HILLSBOROUGH COUNTY SHERIFF'S OFFICE
RFP 1-17 PINEBROOK II RENOVATIONS
QUESTION & ANSWER

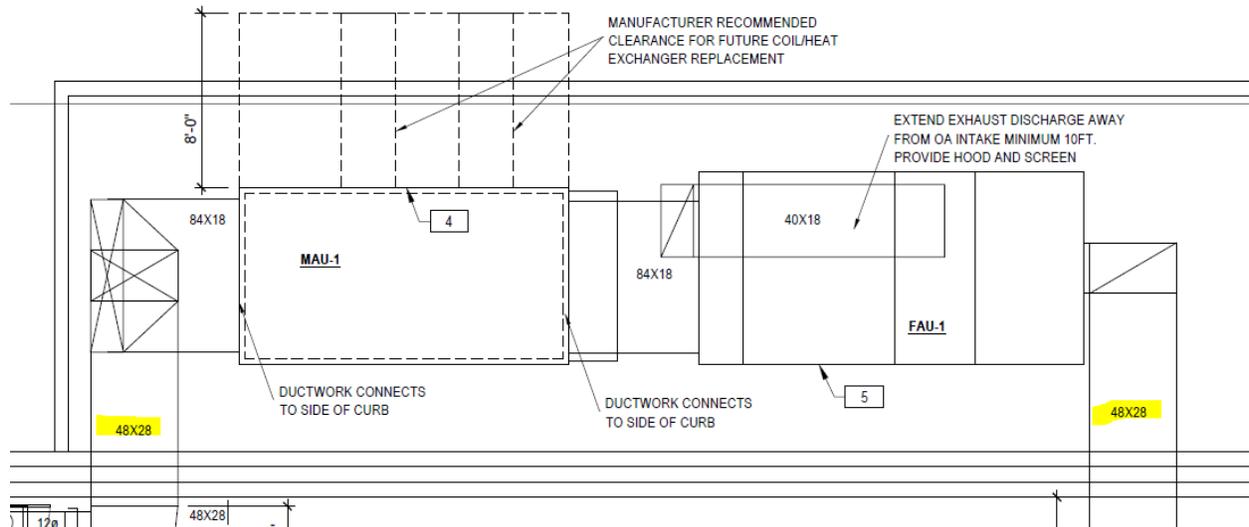
Question #15: Sheet A1.0 legend for FE-1 & FE-2 appear to be backwards, please verify.

Answer #15: A/E response: YES – the legend is backward. FE-1 is cabinet mounted. FE-2 is bracket mounted. This comports with the specifications as well.
